Access Compliance Report

Public Rights-of-Way

Intersection ID: 12492	Main Street: S_COLLEGE_ST	Cross Street: E_4TH_ST	Location: W
ADA ID: DC9072EC637A	Ramp Type: BlendTrans1	Initial Pass/Fail: Pass	Overall Compliance: No
			Severity Score: 0.25

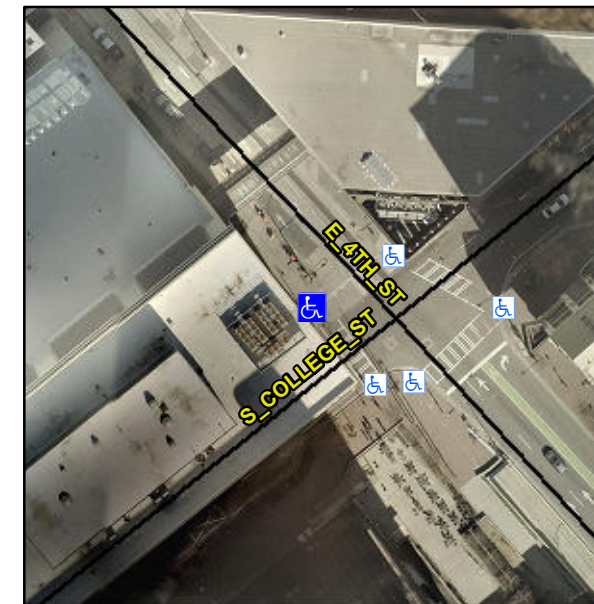
R304.5.3, R305.2, R207.1

Compliance	Description	Data	Compliance	Description	Data
N/A	Ramp Length (in)	65.0	Yes	BlendTrans Slope (%)	1.0
Yes	Ramp Width (in)	48.0	No	BlendTrans XSlope (%)	3.0
N/A	Flare Type LT	Sloped	N/A	Flare Type RT	Sloped
N/A	Flare Slope LT (%)	3.5	N/A	Flare Slope RT (%)	2.8
N/A	Flare Traversable LT?	No	N/A	Flare Traversable RT?	No
Yes	Landing Length (in)	48.0	Yes	DWS Provided?	Yes
Yes	Landing Width (in)	48.0	Yes	DWS Contrast?	Yes
Yes	Landing Slope (%)	1.5	Yes	DWS Length (in)	25.0
Yes	Landing X Slope (%)	0.7	Yes	DWS Full Width?	Yes
N/A	Landing Curb? (Y/N)	No	No	DWS Offset (in)	4.0
N/A	Shared Landing?	No			
Yes	Gutter Ponding?	No	Yes	Gutter Slope (%)	0.2
Yes	Gutter Lip Ht (in)	0.0	Yes	Gutter X Slope (%)	0.4
N/A	Painted X Walk1?	Yes	N/A	Painted X Walk2?	Yes
	X Walk 1 Direction	To NE		X Walk 2 Direction	To SE
	X Walk 1 Width (in)	108.0		X Walk 2 Width (in)	110.0
	X Walk 1 Slope (%)	0.1		X Walk 2 Slope (%)	0.1
	X Walk 1 X Slope (%)	0.4		X Walk 2 X Slope (%)	0.3

Yes	Ramp inside XWalk1?	Yes	No	Ramp inside XWalk2?	No
	Road Slope (%)	0.4		Clear Space?	Yes
	Road X Slope (%)	1.2	Yes	Clear Space to XWalk (in)	48.0
Yes	Any Obstructions?	No	Yes	Storm Grate/Utility Hazard?	No
	Obstruction Type			Storm Grate/Utility Type	
		N/A			N/A
			Yes	Surface Condition? (G/P)	Good
			N/A	Curb Slope (%)	2.2

Remove & Replace Curb Ramp With Two New Directional Ramps or Equivalent. Restripe Crosswalk.
